# URBAN DESIGN COMMISSION APPLICATION

Title: Madison Yards Block 4 Hotel

This letter, together with plans, application and supplemental materials, constitutes our Land Use Application for Major Amendment to an Approved Planned Development – Specific Implementation Plan (PD-SIP) for the proposed Madison Yards at Hill Farms, Block 4 project.

6 SCREEN WALL - NORTH (PARKING)  
1/8" = 1'-0"

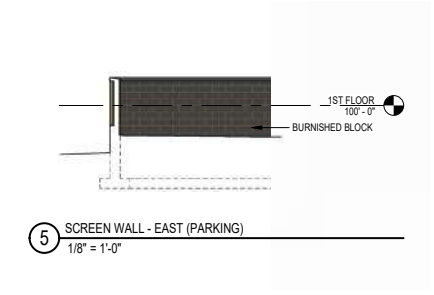
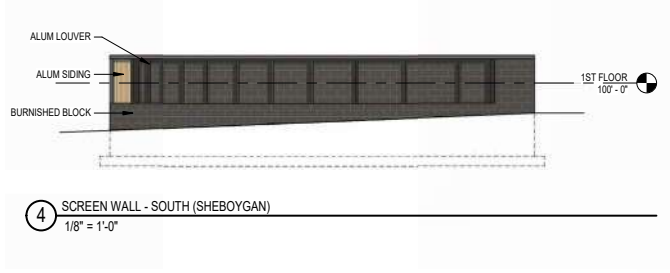
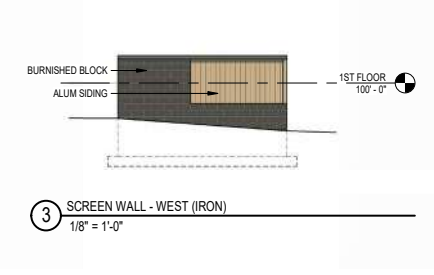
***5. The screen wall shall be at lower in height and the materiality needs to be modified to be more open/permeable. The wall shall be designed with materials consistent with the building materials, including burnished block and faux wood fins. The wall location shall align with the building in plan view and datum.***

2 WEST ELEVATION  
1/8" = 1'-0"

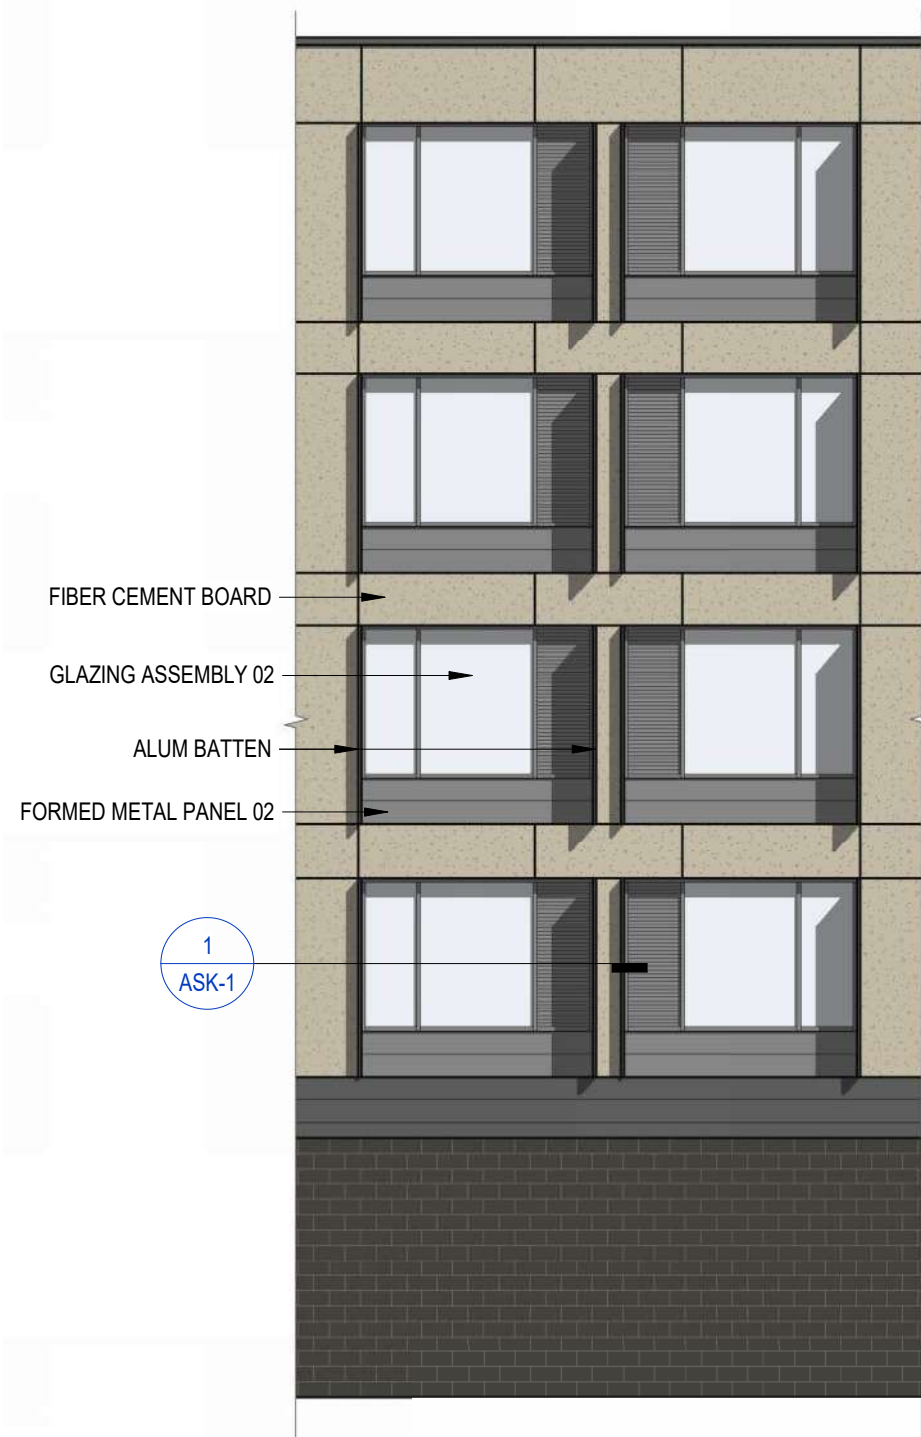
11. *Revise the west elevation to corporate design details or material textures that break-up/minimize the blank expanses on the elevation.*

## TYPICAL WINDOW

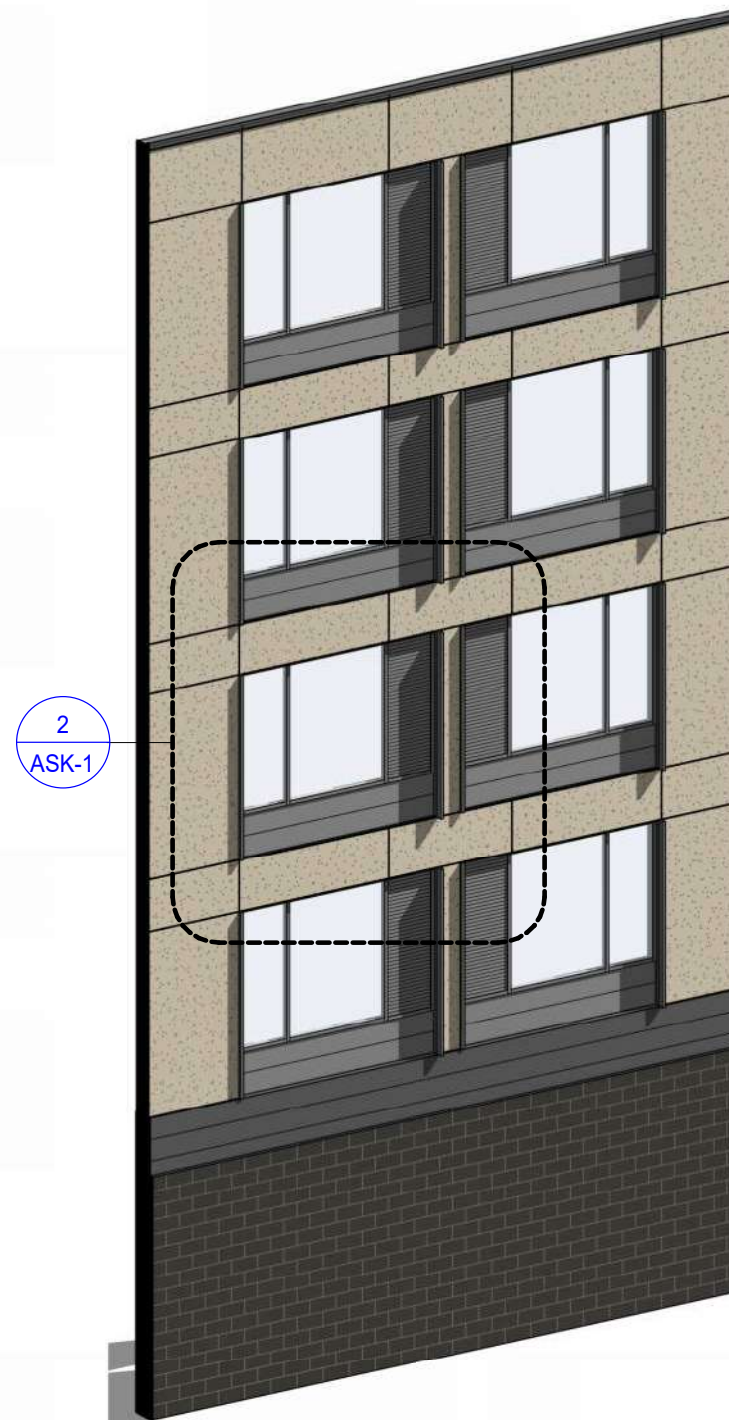
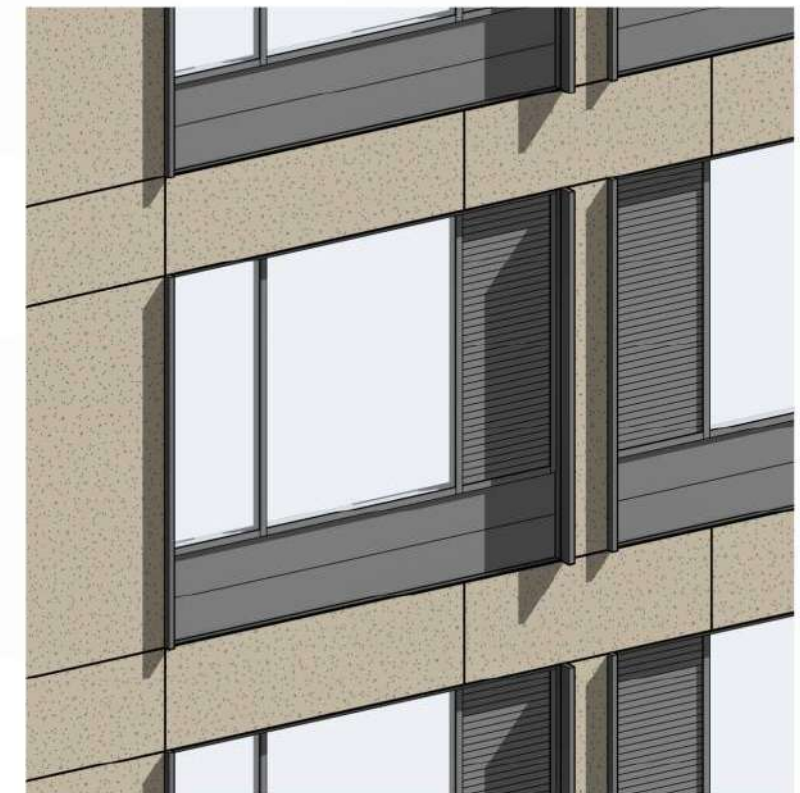
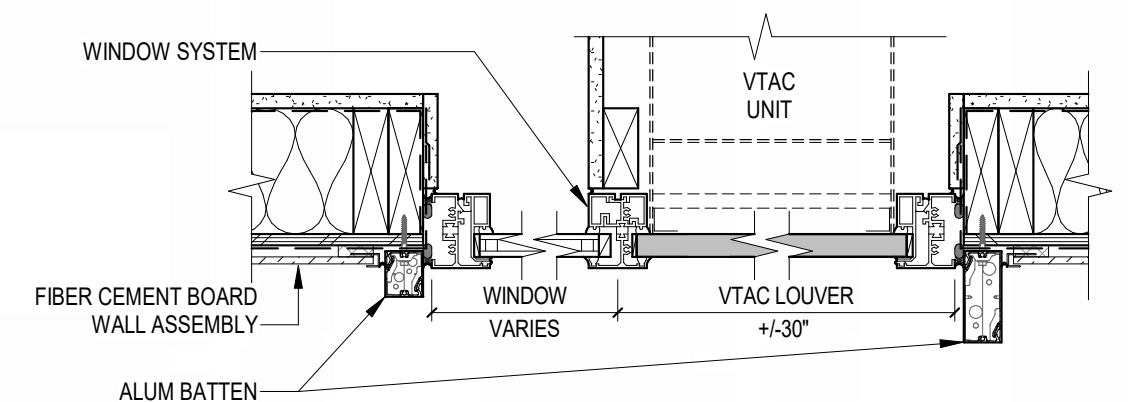
***9. Provide details on material transitions between the metal panel and fiber cement. Consideration should be given to incorporating treatments that provide more relief between the fiber cement and metal panel, including providing a wide trim piece around the window surround to break-up the transition.***

- The project team has designed a trim between the window opening and the fiber cement siding to provide a shadow line between the materials.

Sheet Title  
**BLOCK 4  
LANDSCAPE DETAILS &  
NOTES**

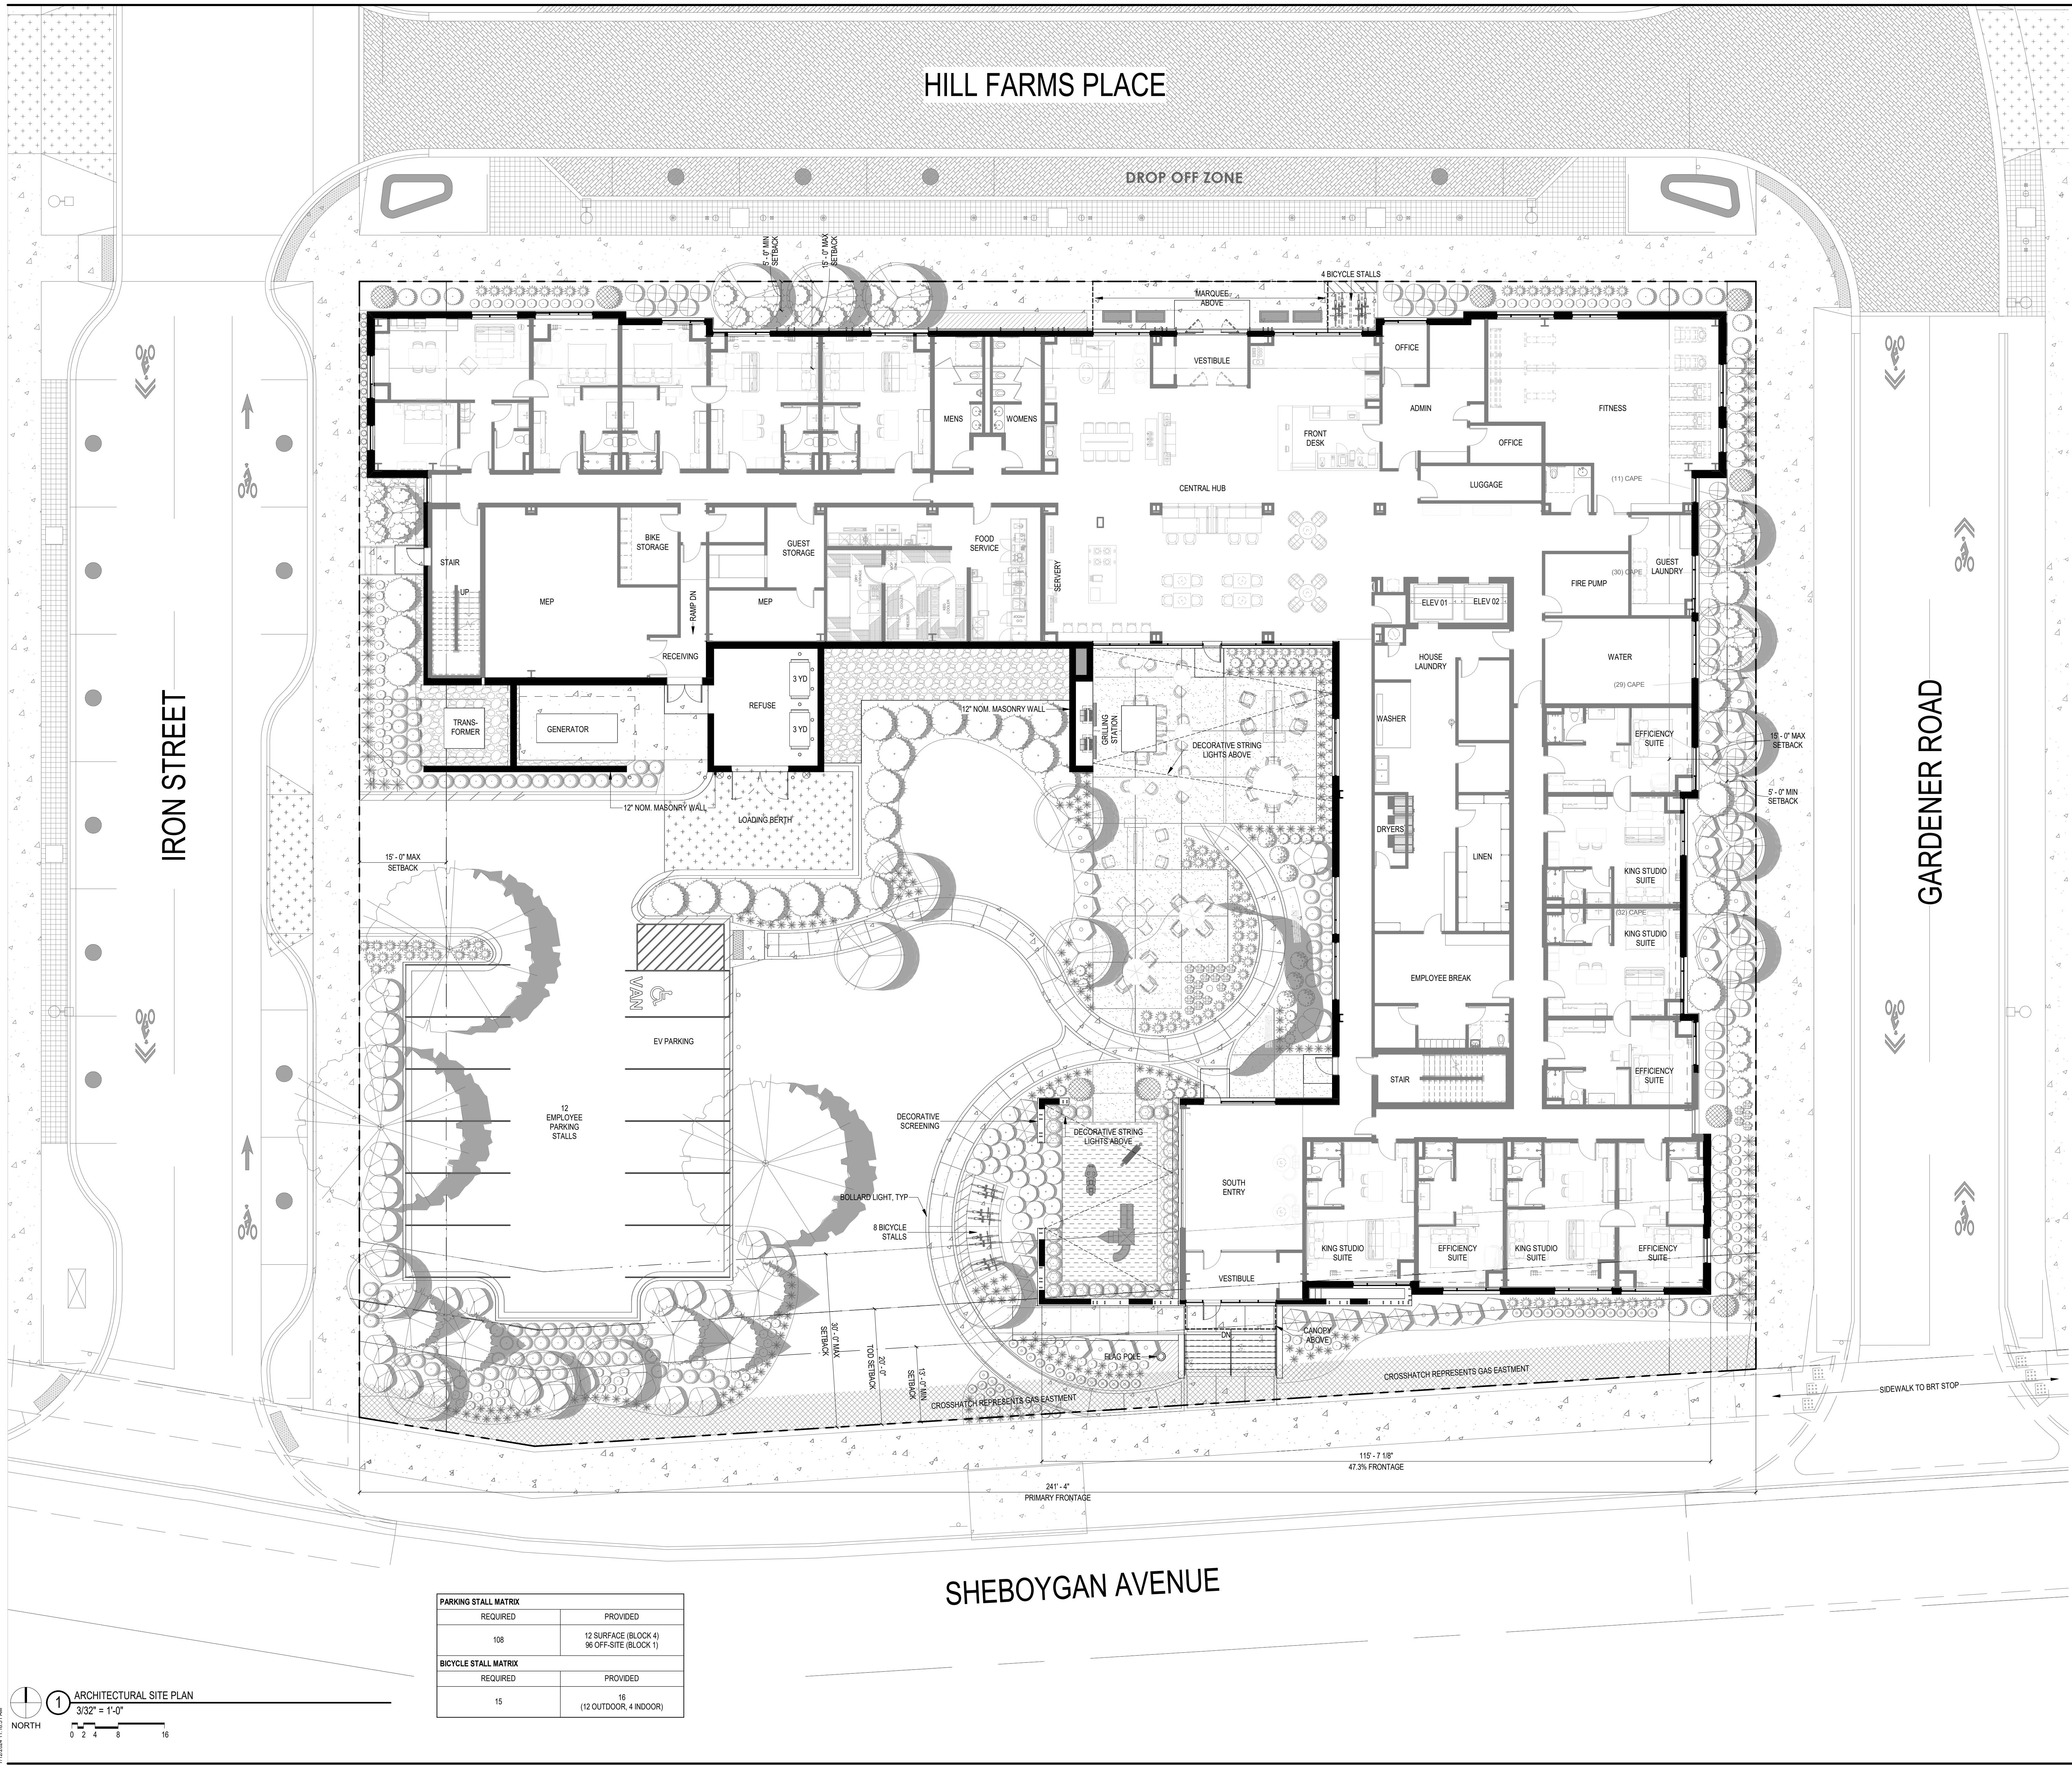
***6. The sun-loving, prairie style plants on the north side of the building shall be replaced with a more shade tolerant selection.***

***8. Tree plantings located at the screen wall and between the loading area and the public lawn shall be at least a 2.5-inch caliper.***

- The project team has updated the planting plan to address the comment.

- The project team has updated the planting plan to address the comment.
